**KEIZER PLANNING DEPARTMENT
NOTICE OF DECISION
Partition Case 2023-09**

The following report reviews a land use application to divide an existing parcel totaling approximately 28,319 square feet into three lots comprised of approximately 5,566 net square feet (Lot 1), 5,559 net square feet (Lot 2) and approximate 5,482 net square feet (Lot 3). The parcels will be served by a private access easement and a duplex is planned to be built on each lot. The subject property is zoned Single Family Residential (RS). (Exhibit 1)

A SITE PLAN

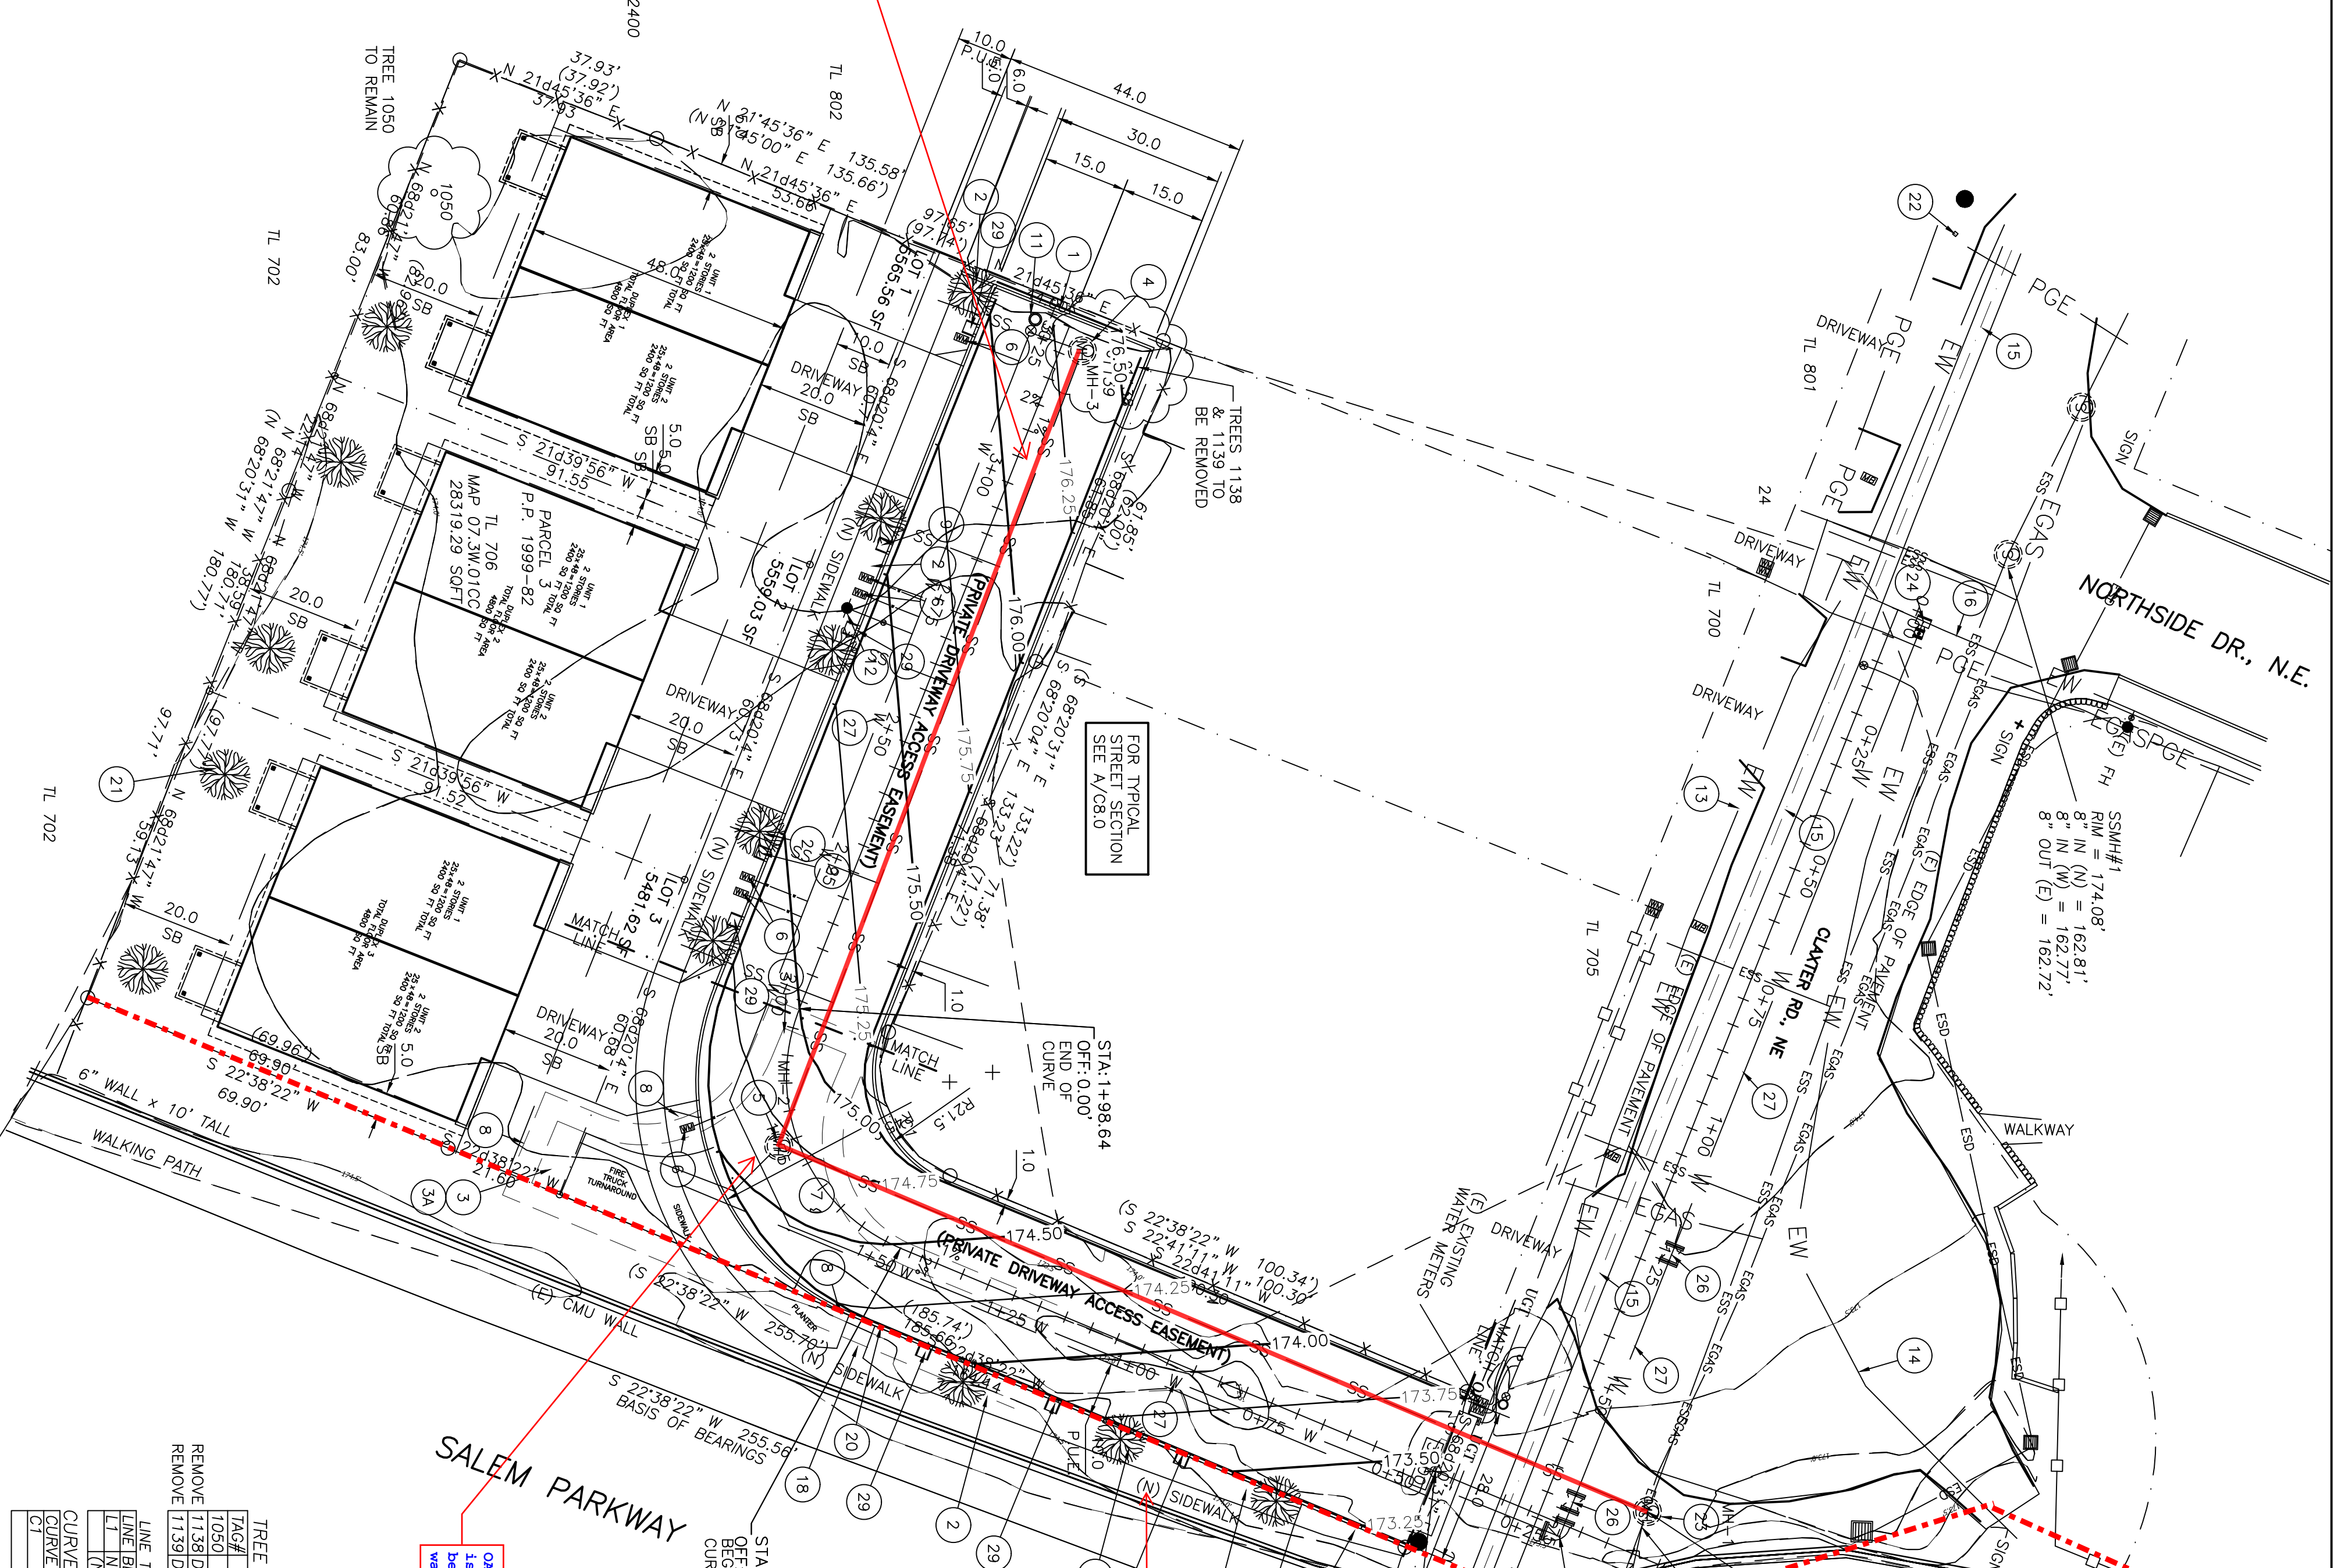
Our Agency's comments are: The proposed connection to sewer will require construction permits in accordance with the Salem Revised Code, the Public Works Design Standards, and Standard Construction Specifications. Permits will not be issued by the City of Salem Permit Application Center until all construction plans have been approved by the Public Works Department. Construction drawings can be submitted by email to: developmentservices@cityofsalem.net. A portion of the proposed improvements appears to be within Salem City Limits and the Dr. Martin Luther King Jr. Parkway Right-of-way, which is under ODOT Jurisdiction. Please see attached redline comments.

RELOCATE (E) AT (N) MANHOLE

This could be very expensive depending on the main size.

Approx Salem City Limits
